2 ARCHITECTURAL ADDENDUM

3 MECHANICAL ADDENDUM

**The following changes/clarifications in the tender documents are effective immediately.
This addendum will form part of the contract documents.**

PACIFIC AGRI-FOOD
RESEARCH CENTRE
MECH & ELEC RETROFIT

1 CONDENSER WATER LOOP SCHEMATIC PHASE 2B
N.T.S.
MSK-01

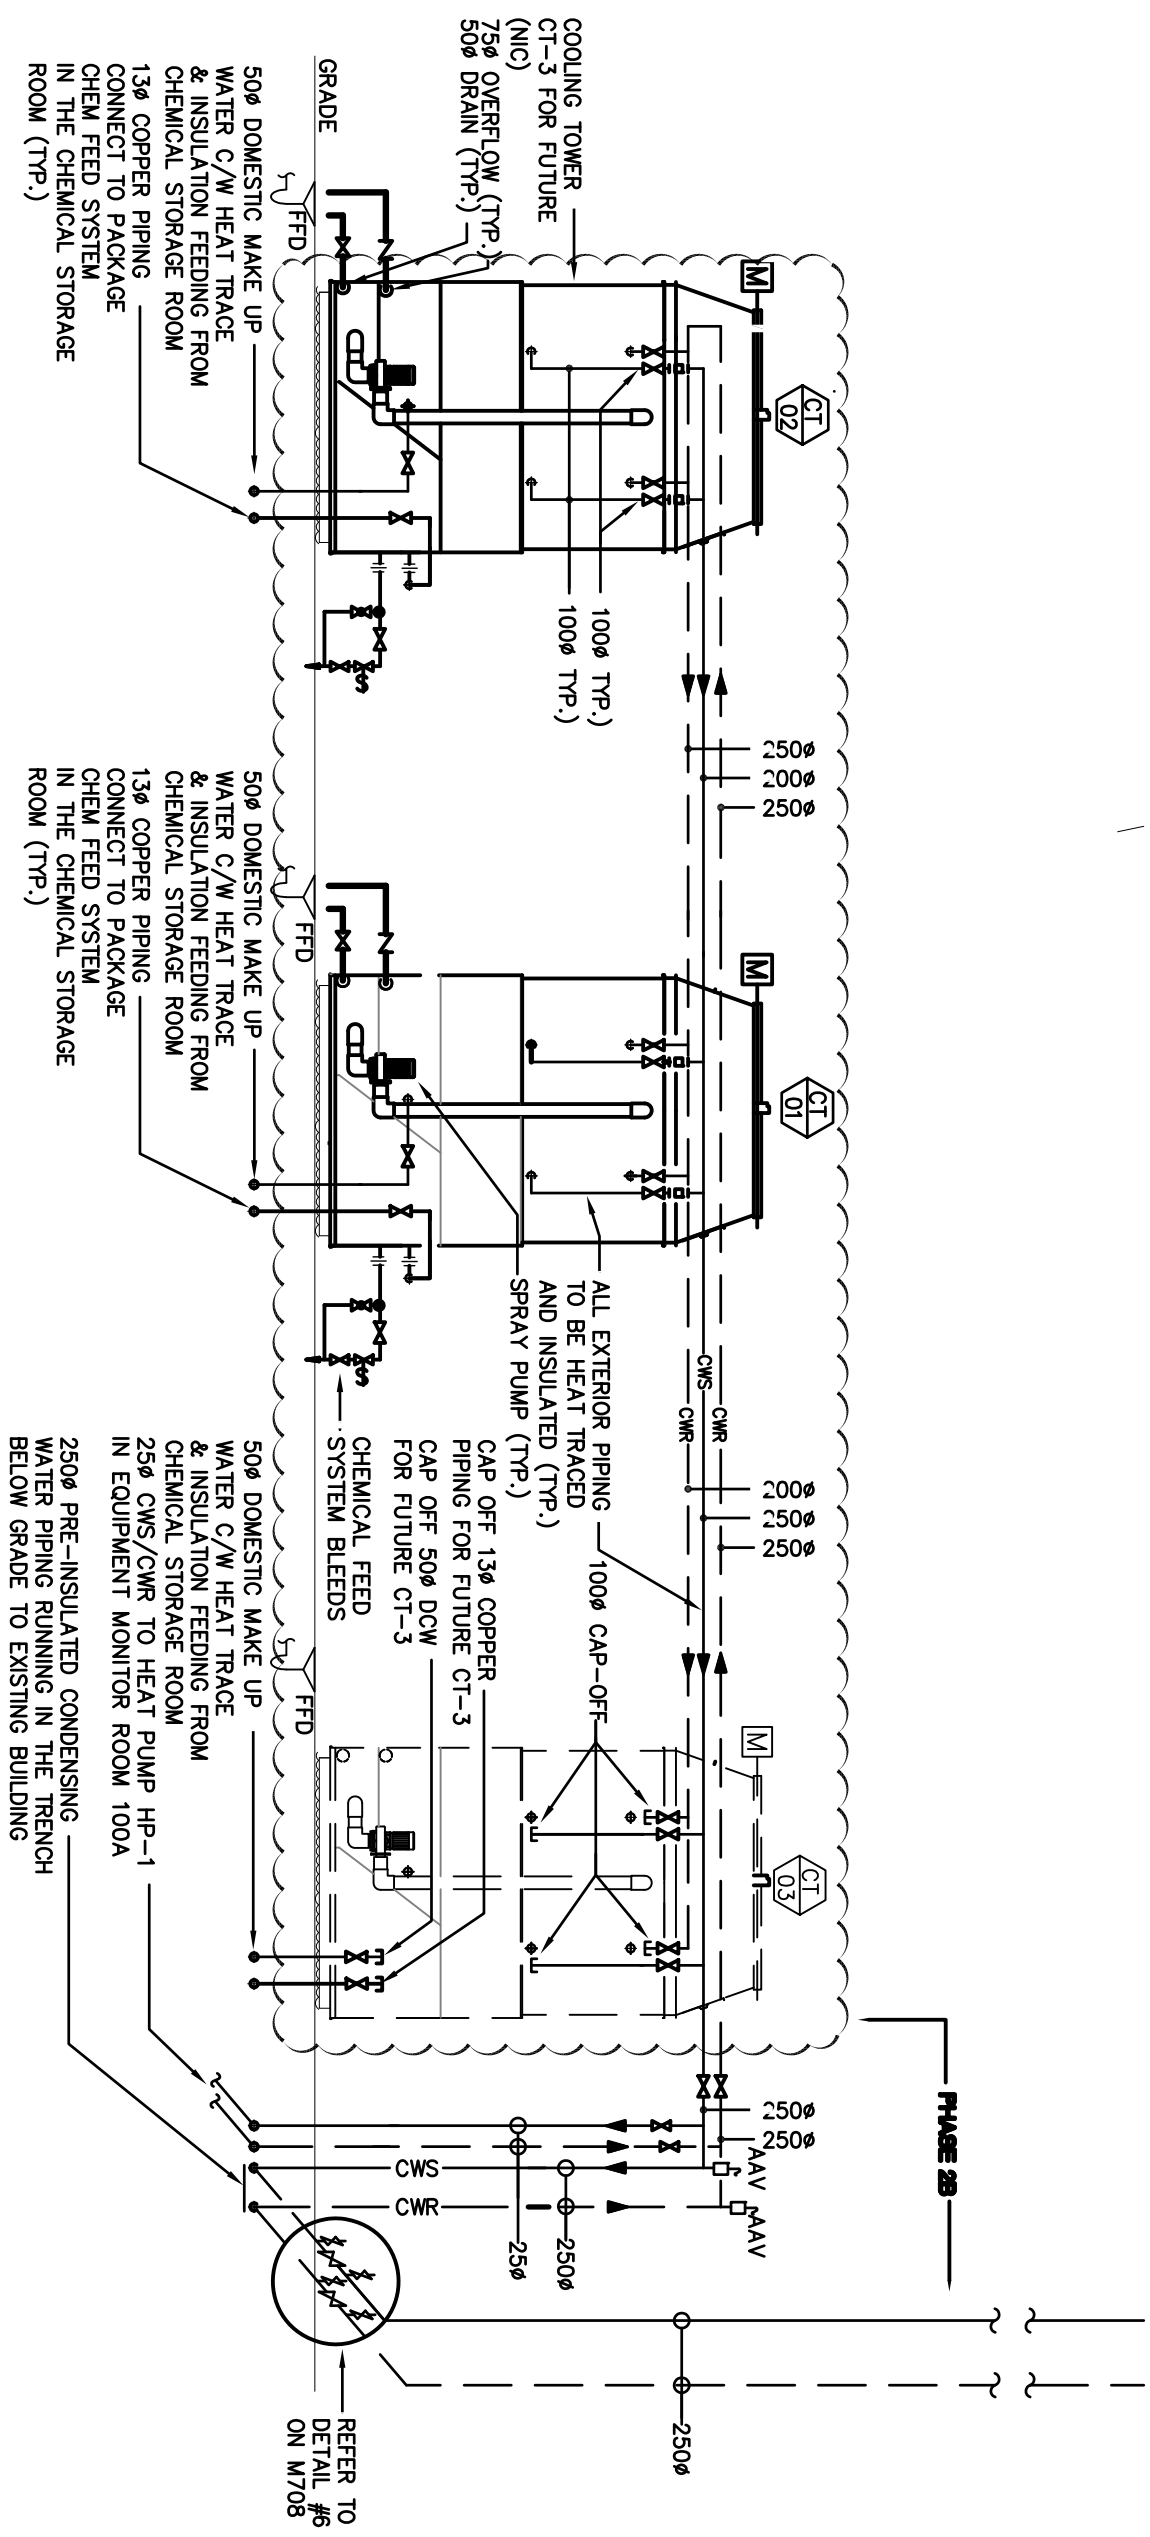
- .1 Drawing M701
 - .1 Revise the drawing per enclosed sketch MSK-1. Note: Changes depicted also apply to drawings M703, MM704, M705 and M706.
- .2 Drawing M812
 - .1 Revise the drawing per enclosed sketch MSK-3.
- .3 Drawing M815
 - .1 Revise the drawing per enclosed sketch MSK-2.

GENERAL NOTE:
THE CHANGES APPLY TO MECHANICAL
DRAWING M701, M703, M704, M705 AND
M706

FIRST FLOOR PLAN

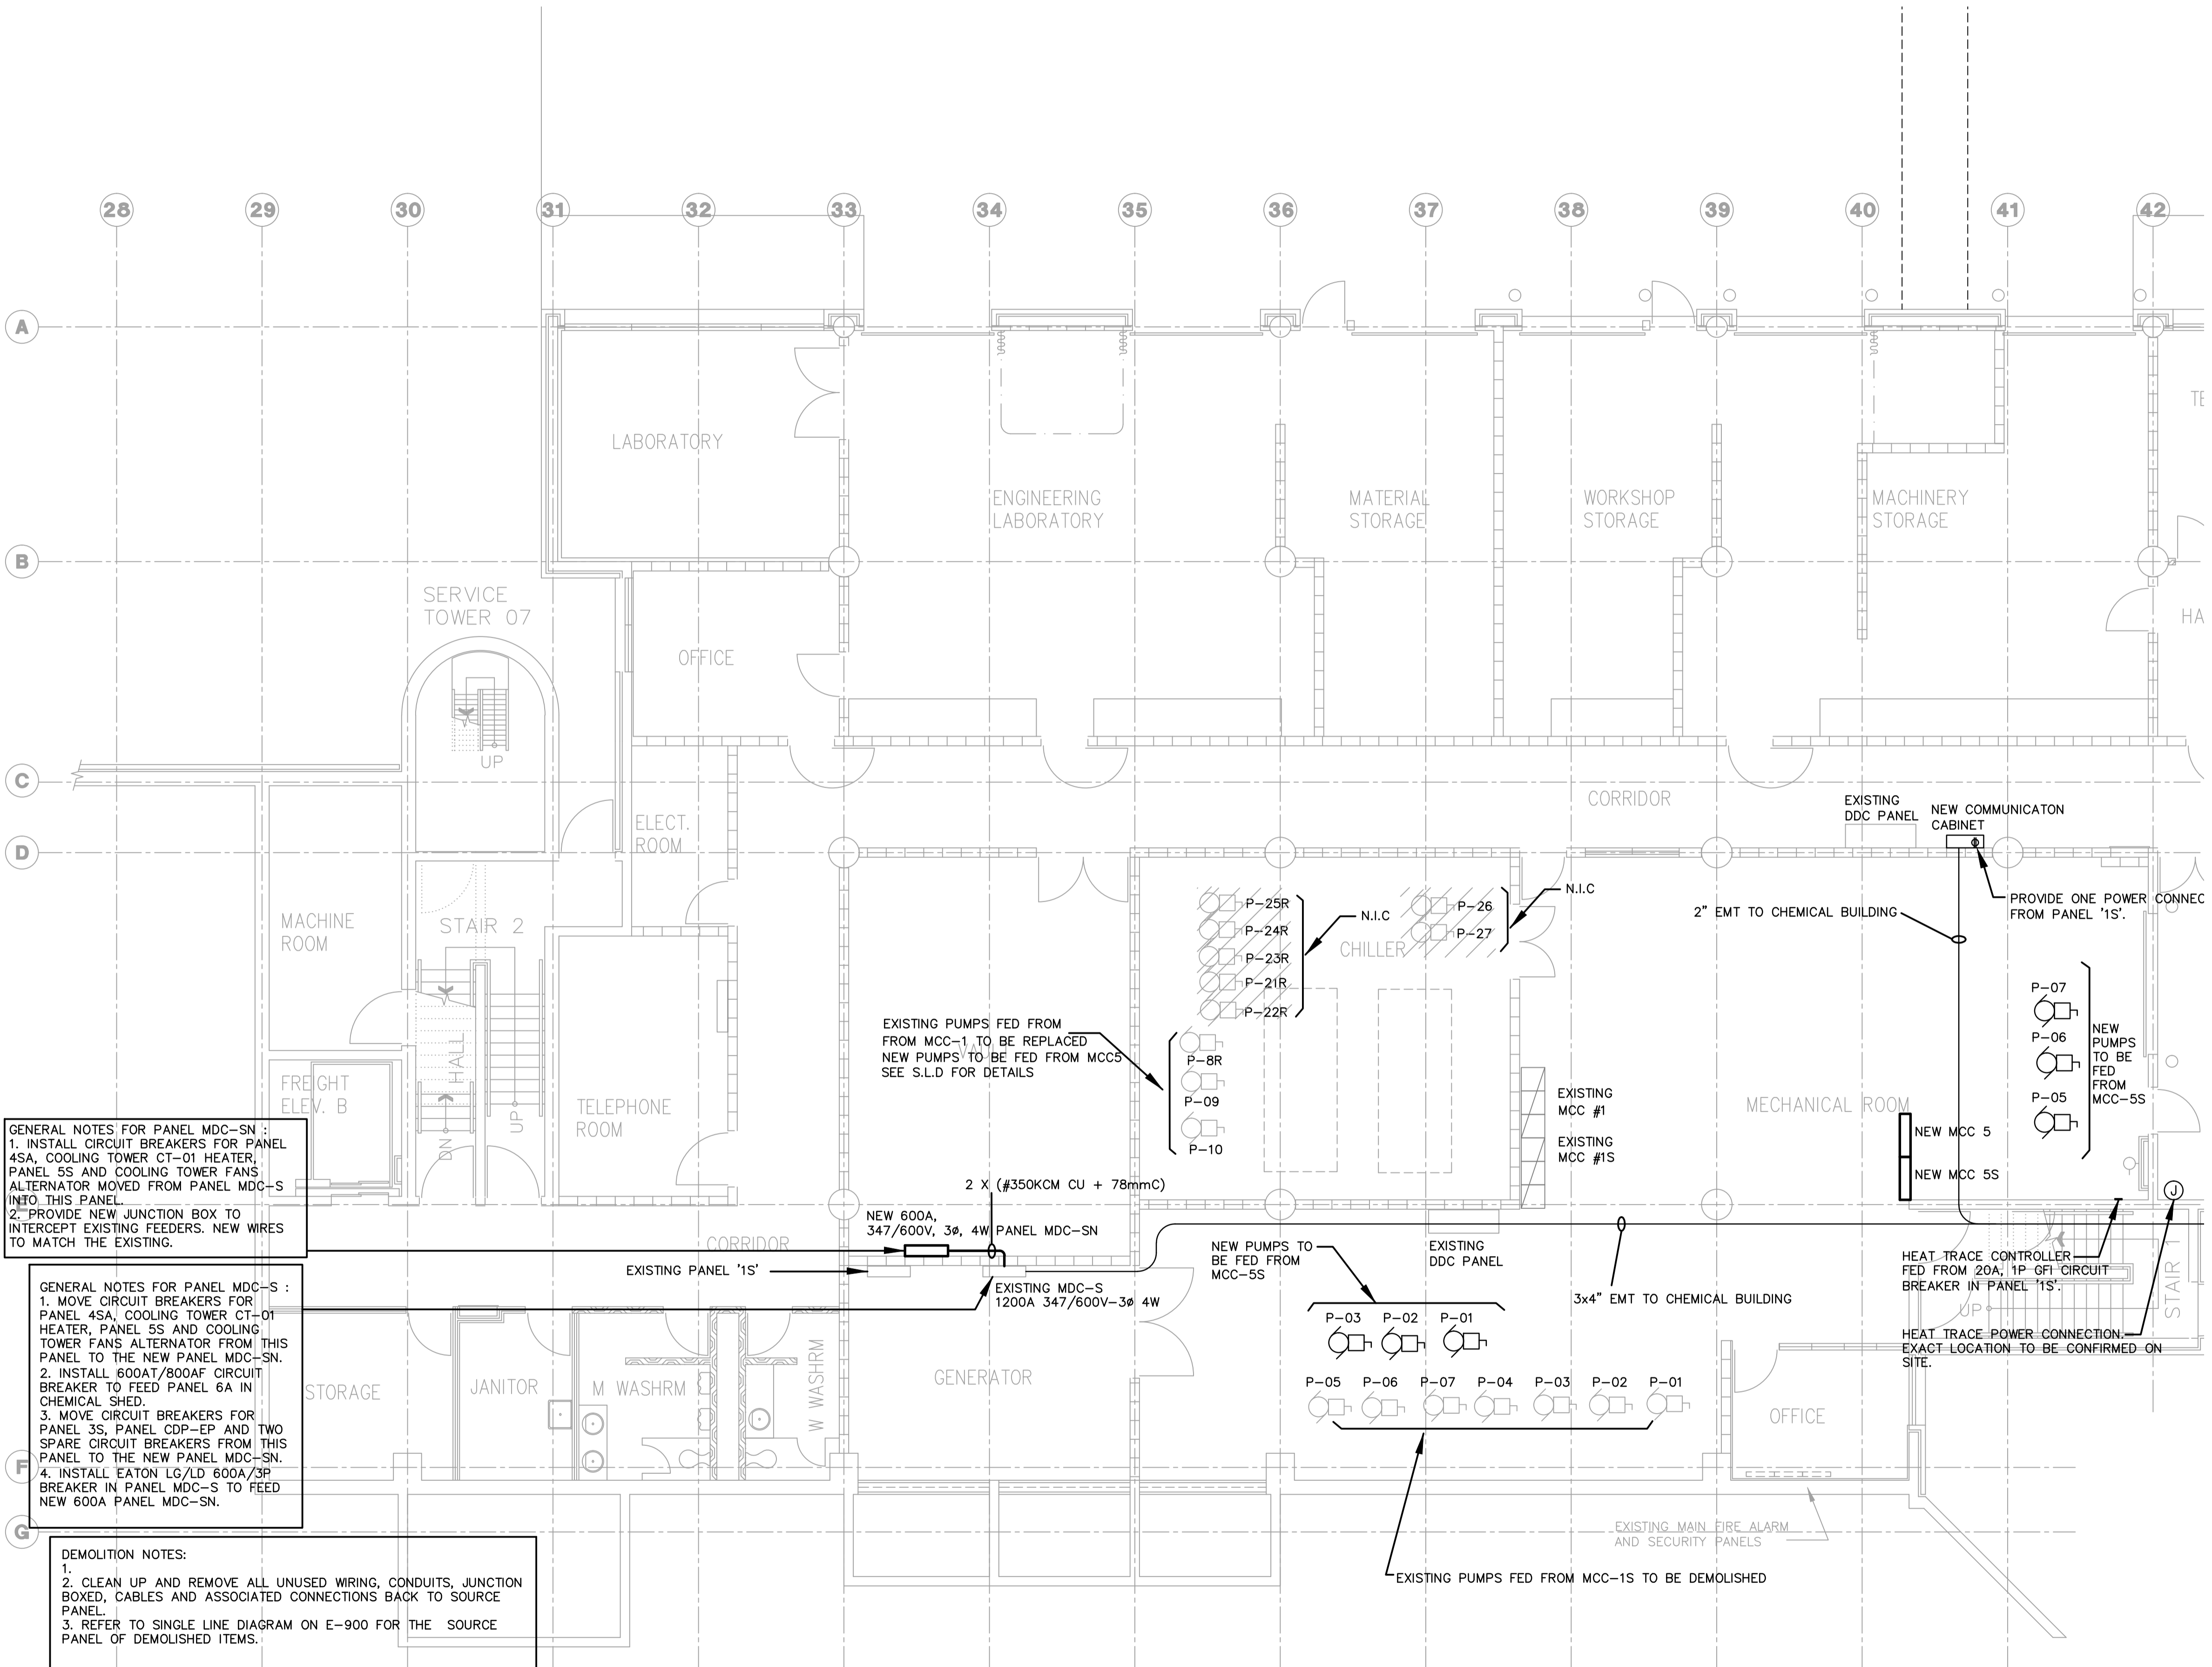
- .1 Refer to drawings E-150, E-800, E-810, E-820 attached
- .2 Drawing E-150
 - .1 Add drawing scale and scale bar.
- .3 Drawing E-800
 - .1 Move conduits for power and communication to follow the same trench path as mechanical pipes.

- .1 Q1: Drawing E-150 indicates the location for a new Panel MDC-SN. This location currently has live electrical equipment installed along the entire length of the wall. There is no space for any new electrical equipment on this wall. Please advise where this new panel should be installed.
A1: Install unistrut, mount Panel MDC-SN on the unistrut and offset from the wall on top of the existing conduits on wall.

- .11 Q11: Drawing E-150, bottom LH corner Demolition note references a panel and transformer to be demolished and removed from site. Please advise equipment numbers and location of this equipment.

A11: This note is not applicable in this project.
